REPORT TO: **COUNCIL ASSESSMENT PANEL**

SUBJECT: **DEFERRED ITEM – 3 SKYE STREET, SEACLIFF PARK - DEVELOPMENT APPLICATION 110/00415/19**

TWO STOREY DETACHED DWELLING WITH INTEGRAL GARAGE LOCATED ON SOUTH EASTERN SIDE BOUNDARY (ALLOTMENT 101 – 1/28 OPHIR CRESCENT, SEACLIFF PARK)

FRONT ELEVATION - RES 2
SCALE 1:100

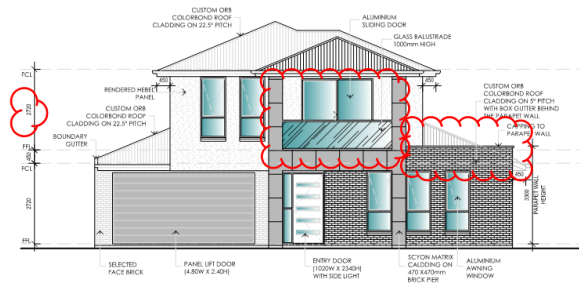
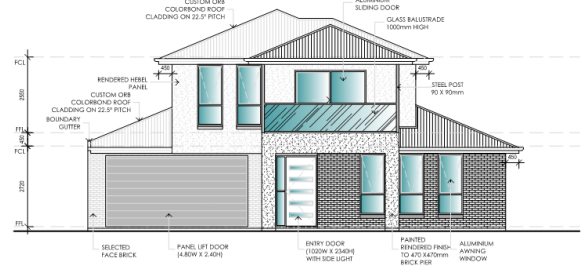
- The front balcony on the building façade has been redesigned to minimise the visual bulk and scale;
- The lower level roof form changed from parapet to hipped roof on the front elevation;
- The building height reduced by 170mm following a reduction in upper level ceiling height.
